AIR - LPC BLEED MASTER ACTUATOR - NEW FUEL DRAIN PASSAGE - CATEGORY CODE 6 -
MOD.ENG-75-0023

V2500-ENG-75-0023

1666-75-002

ENGINE COMPRESSOR CONTROL - LPC BLEED -
MASTER ACTUATOR - INTRODUCTION OF
DRAIN BETWEEN LVDT, LP SEAL
AND LVDT SHAFT DUST SEAL

Modification of the LPC Bleed-Master Actuator
Fig.2

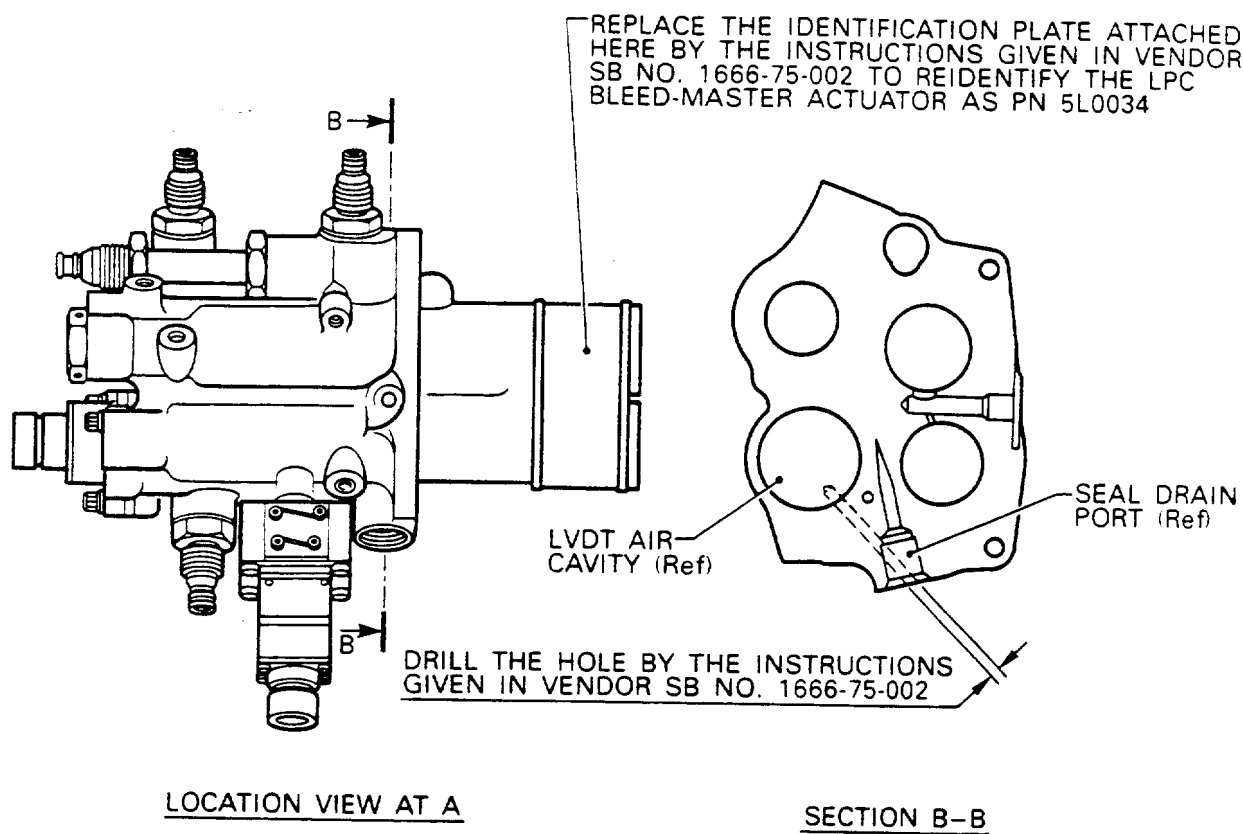
- (1) The changes introduced by this Service Bulletin are as follows: Refer to Figure 1 and 2.
 - (a) A drain passage between the LVDT air cavity and the unit seal drain port is introduced to prevent the hydraulic locking of the LVDT.
 - (b) Existing Part Number of LPC Bleed-Master Actuator is changed to a new Part Number.
- (2) Existing LPC Bleed-Master Actuator can be reworked and reidentified to a new Part Number.
- (3) New LPC Bleed-Master Actuator Assembly will be available for future replacement purposes.
- (4) The following Service Bulletin must be incorporated in conjunction with this Service Bulletin:

Body , insert and plugs assembly -
re-work details
Figure 1

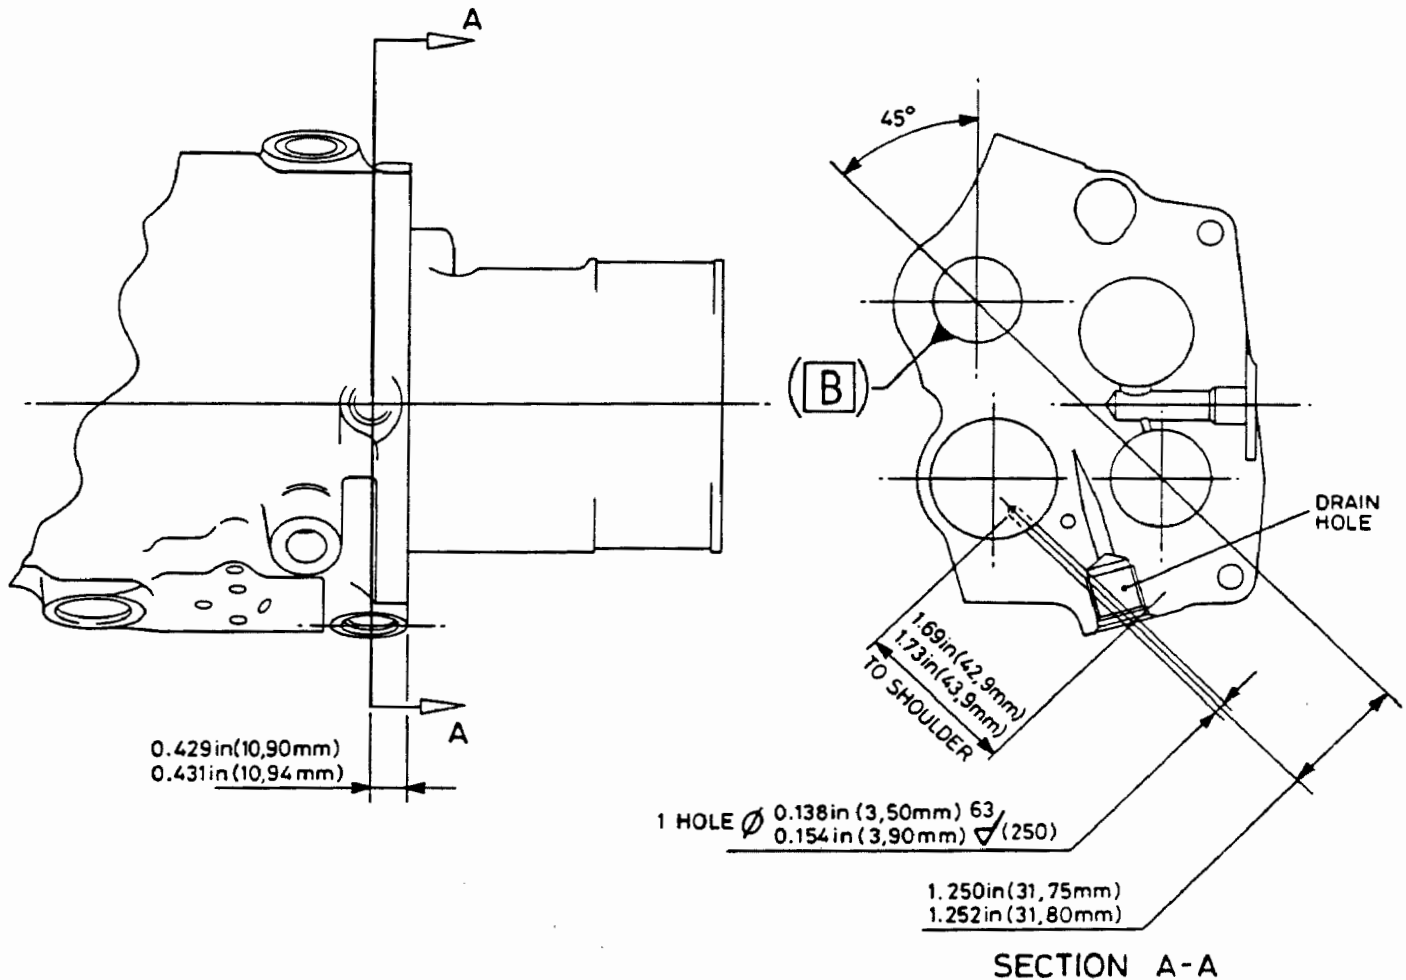
A. Re-Work Instructions (Figure 1).

- (4) Install the body on a jig boring machine and set the body as shown in relation to the machine spindle axis; use the actuator piston hole in the body as datum B.

- (5) Machine a hole 0.138-0.154 in.(3,50-3,90 mm) dia. from the drain hole to the LVDT cavity as shown, (Refer to Figure 1).
- (6) Remove the body from the jig boring machine and remove, by using hand tools, any burrs from the machined hole in the LVDT cavity.
